CHRIST CHURCH BEXLEY

DEVELOPMENT APPLICATION DESIGN REPORT

COUNCIL RFI RESPONSES

08.03.2023

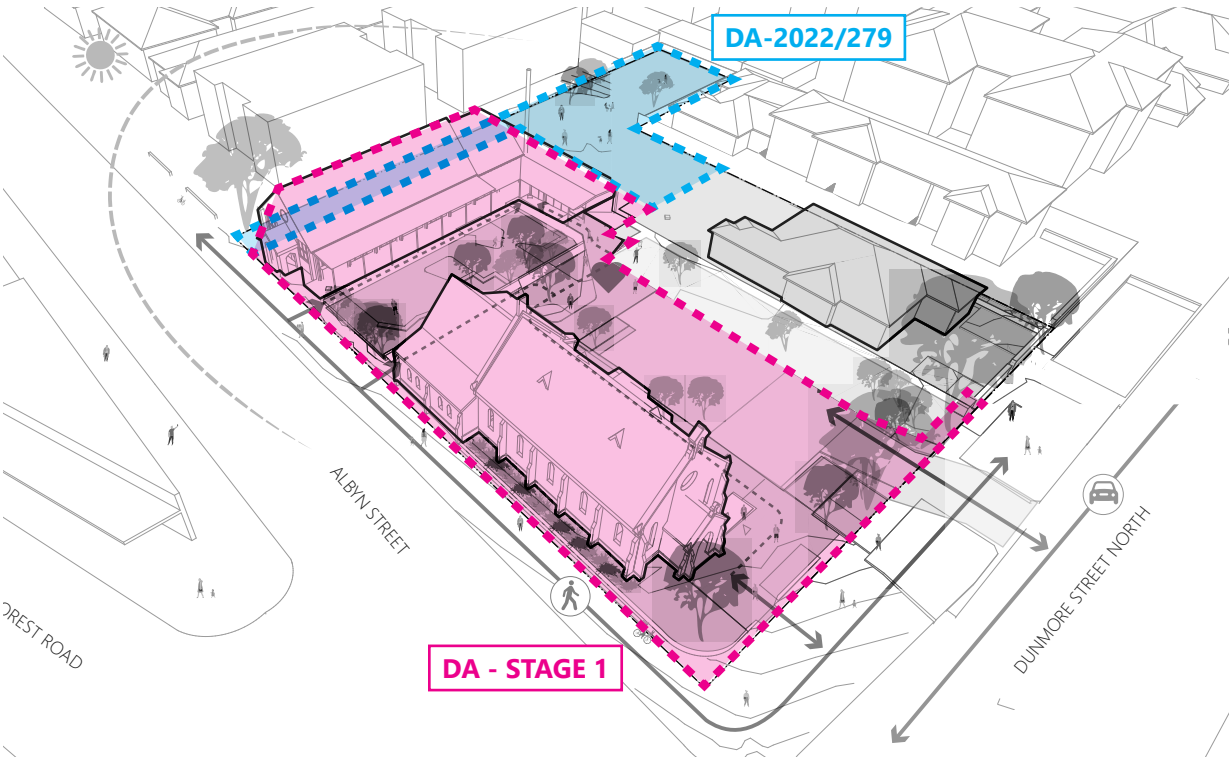
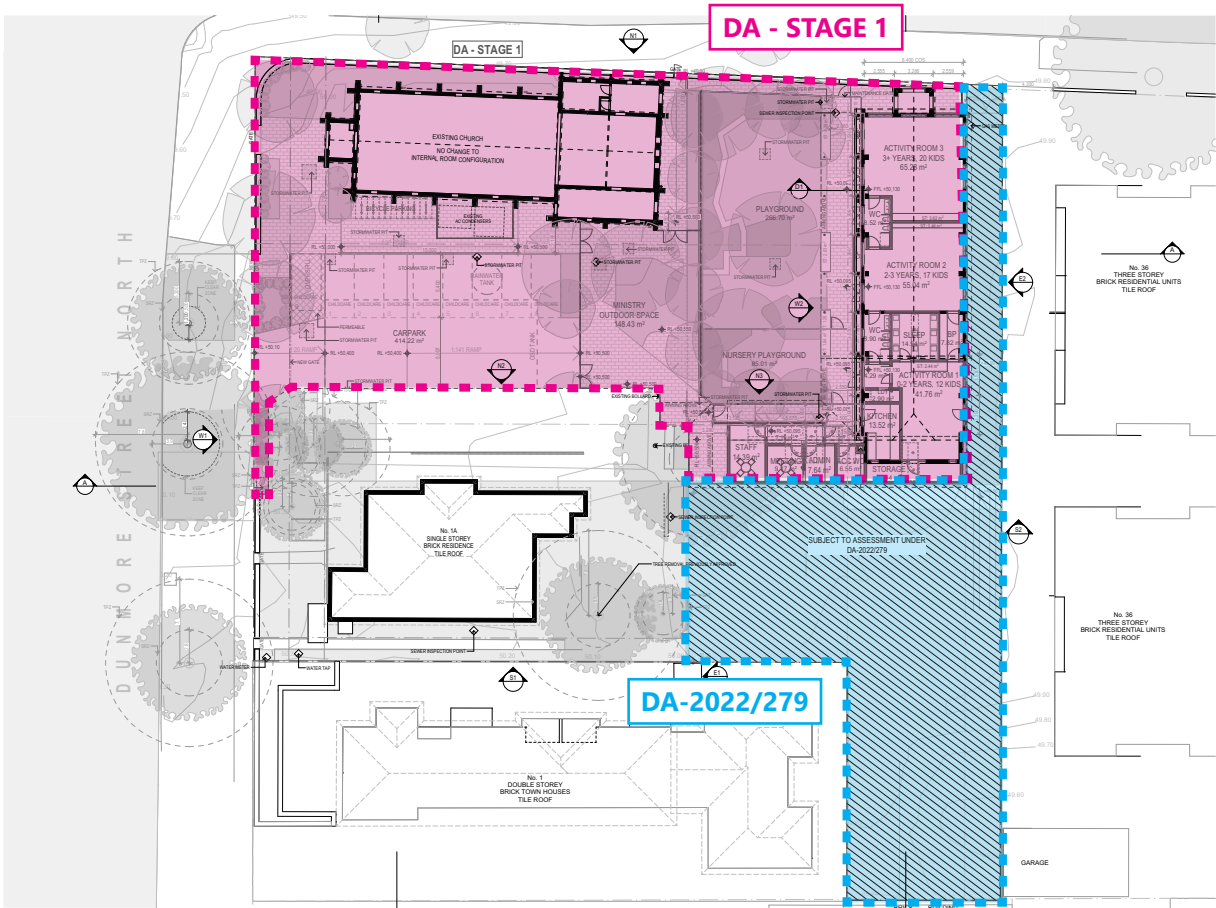
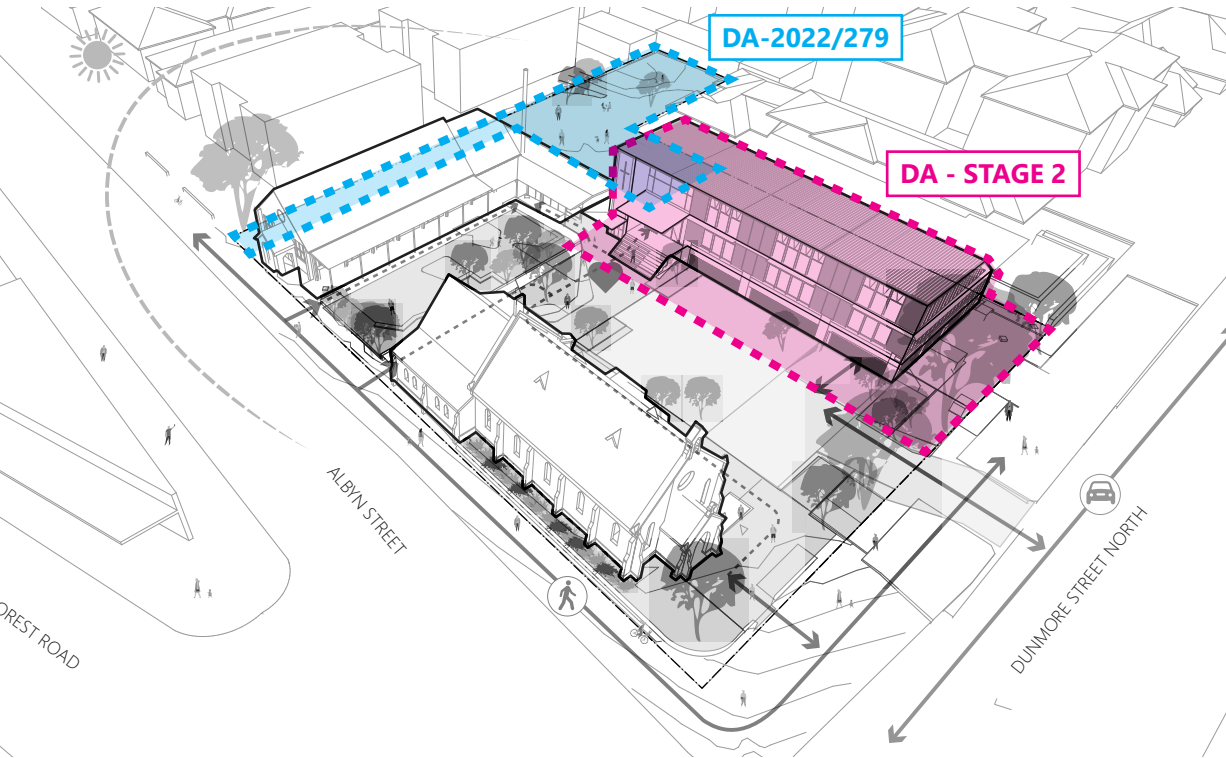
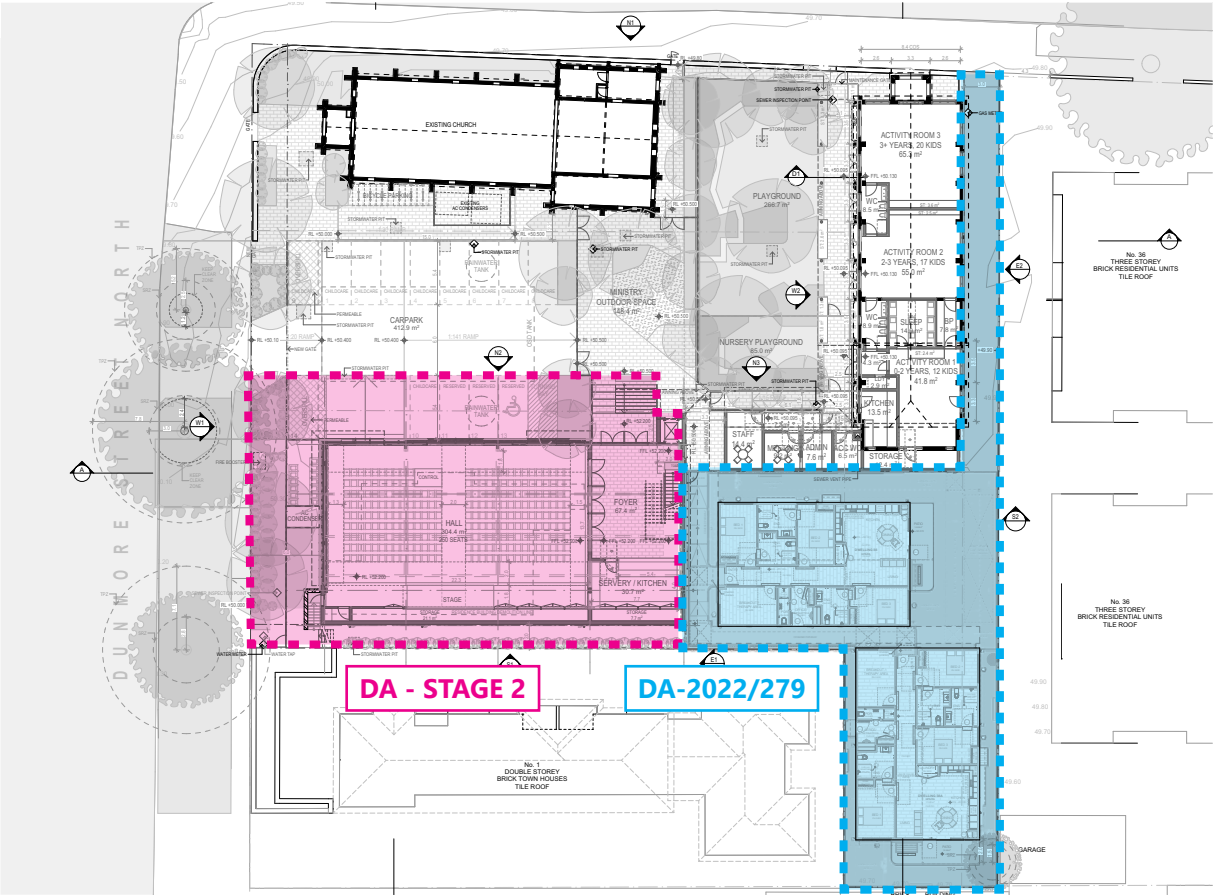
2.0 Urban Designer Comments		
	The option of presenting the proposal to the Bayside Design Review Panel was provided to you however a decision was made to not present the development application to the Panel for consideration. Therefore, an assessment by Councils' Urban Design and Strategy Team was carried out and several concerns were raised as listed below. Amended plans are to be provided to demonstrate the below:	
a	Site planning	
	Site plans indicate that future stages of the development that will be located in the south eastern corner of the site. The applicant is encouraged to provide a more advanced master plan for the entire site to ensure an appropriate and wholistic design response is developed. In particular, the master plan should consider appropriate distribution of building mass across the site and circulation through the site.	Masterplan updated, refer to DA100 Ground floor plan and staging diagrams (below).

Stage 1:

NO	COUNCIL COMMENTS	RESPONSE
		Stage 2:

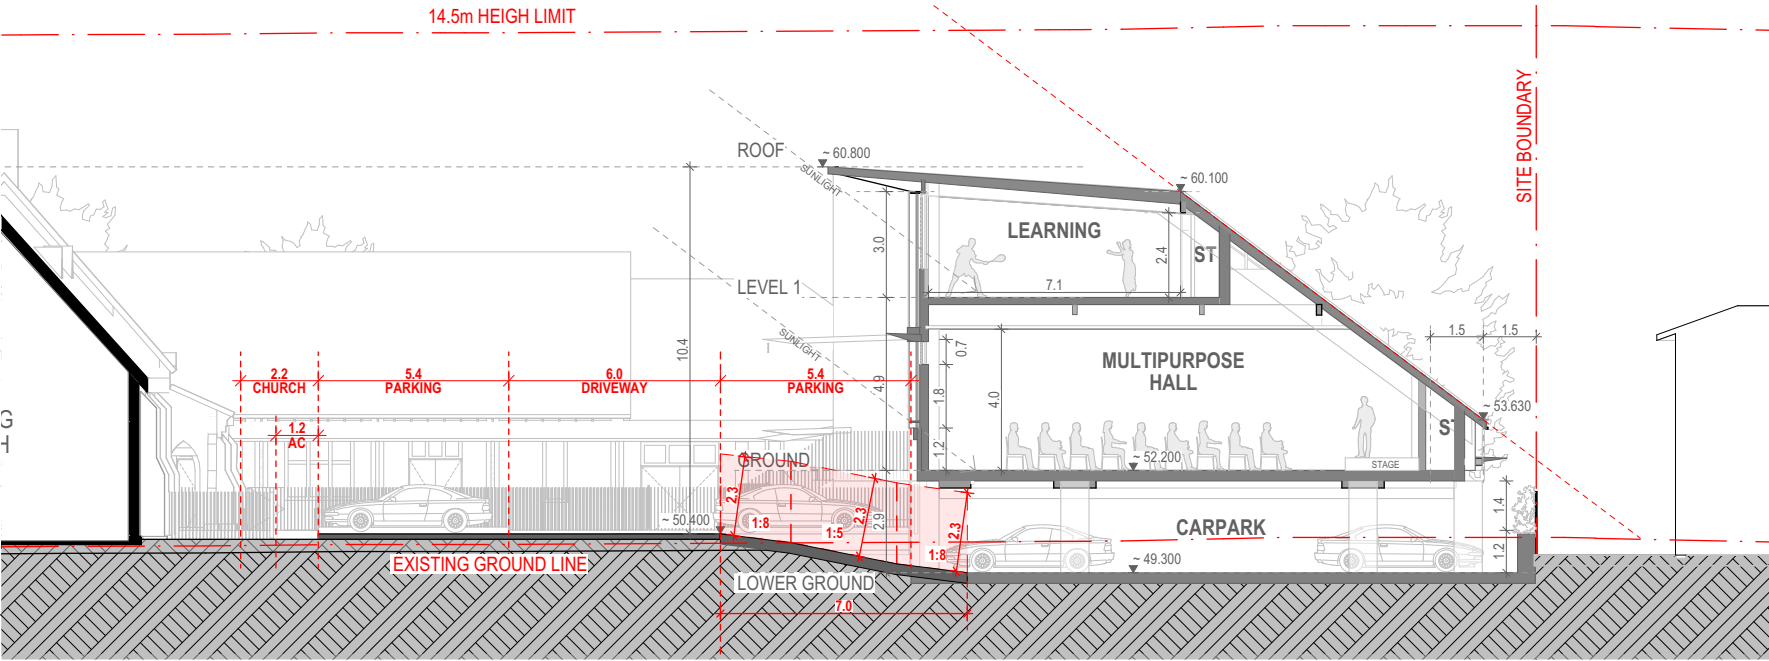
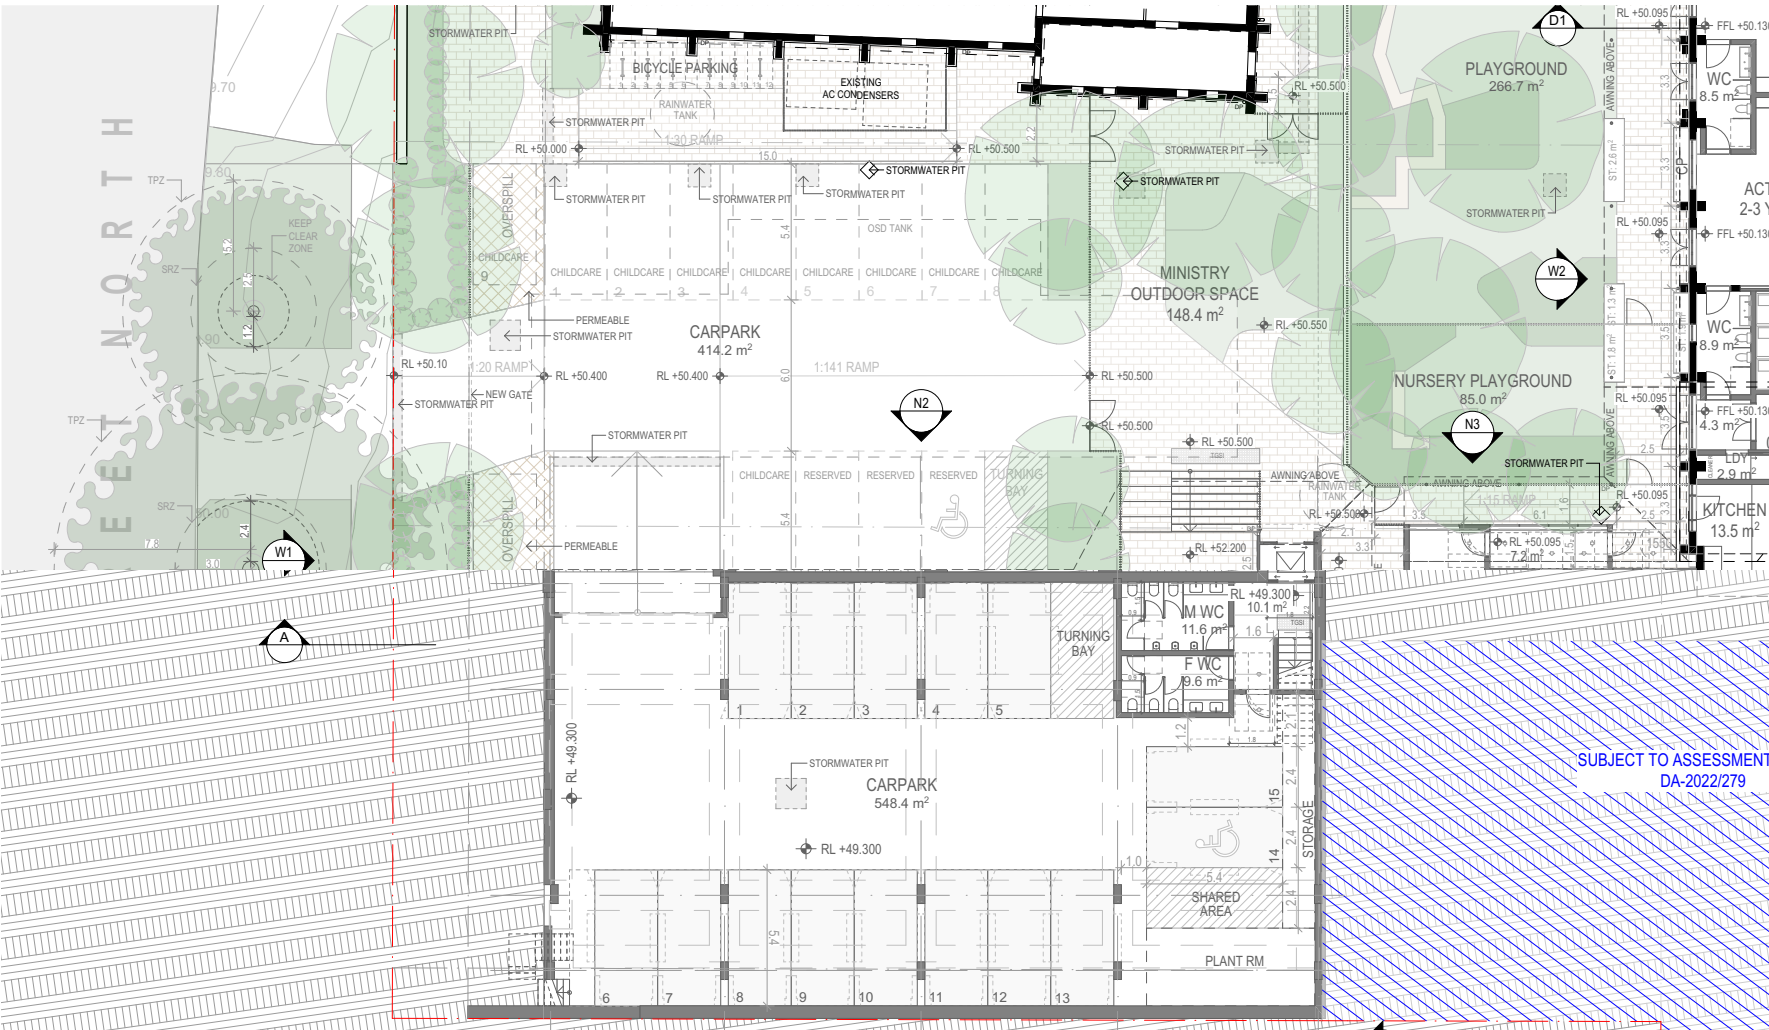
b	Proposed church hall
	<p>The church hall has been elevated 1.7m above ground level to accommodate a carparking level that sits a half level below ground level. This strategy has several negative impacts:</p> <ul style="list-style-type: none">• compromises access to the hall• creates an awkward interface with the ground level by exposing the carpark• increases the height / bulk of the building, given the halls proximity to a heritage structure this is of particular concern.• creates a lower ceiling height running along the southern face of the hall,• forcing stage to be located on the longer southern face of the hall which• compromises acoustics and sight lines from the stage. <p>It is recommended that the ramp providing access to the car park is extended to the southern edge of parking space 1. This will provide a total ramp length of approximately 11m, which will accommodate a change in level of 2.25m (1:4 ramp with 1:8 transitions). This will allow the floor level of the carpark to be lowered to RL 48.15m allowing a fully concealed basement be provided. The ground floor can the lowered to RL 51m creating greater opportunities to provide a more equitable access solution for the hall.</p> <p>This strategy will also allow the upper-level learning space to be set back from the north to provide a north facing terrace and reducing the scale of the northern facade of the hall, to further reduce the perceived scale of the buildings interface with the adjacent heritage structure.</p> <p>Should the degree of building reduction not be feasible, Council can entertain a reduced height less than that proposed above following a discussion with yourselves. It was evident at the kick-off briefing with the SECPP that negotiation between the two parties could be carried out to resolve the issues presented and come to a solution that is acceptable from both parties.</p>

<p>Refer to study diagrams below and in Section 8.0 and updated elevations and 3D perspectives in updated design report below. In summary, we have considered all points and note the following:</p> <p>* The recommendation to lower the basement to address the issues has been considered and is not a simple task because the design overlays other matters besides urban design that we must consider and address. These are investigated below in the responses, but in summary:</p> <ul style="list-style-type: none">• Maximise carparking on site: dimensions for car spaces, car isles and ramp are already minimum and in accordance with the Australia Standards. This dictates where we can locate the on grade car park, basement location and ramp into basement in order to maximise the car parking. In order for us to drop the basement, we cannot maximise the car parking on site (which we note is important for council and the community) or compromise on the hall capacity which would mean we cannot achieve one of the key objectives for the hall which is to accommodate a seating capacity of 250 seats.• The project is already financially challenging as a not for profit community focused project, but if we are required to drop the basement (which is estimated at \$500k as confirmed by WTP quantity surveyors) we will not be able to deliver this project.• The basement at 1.2m below ground level means a more environmental sustainable outcome can be achieved through natural ventilation in lieu of mechanical ventilation which wold be required if the basement is any further in-ground.• The bulk and scale of the building has been raised as an urban design issue of concern from council. We note the overall development is much lower than the fully developable potential of the R4 zoning and the hall building is 4.1m (or 28%) below the maximum height permitted. We have tried to address the proportions of the building and the controversial roof form by redesigning it to reduce the overall scale of the roof form as seen from the southern neighbours and to address the perceived awkwardness of the roof. We hope this is an acceptable outcome especially when compared to other potential outcomes for the site that would result in more adverse and greater impacts to urban design outcomes for the public and the neighbours.
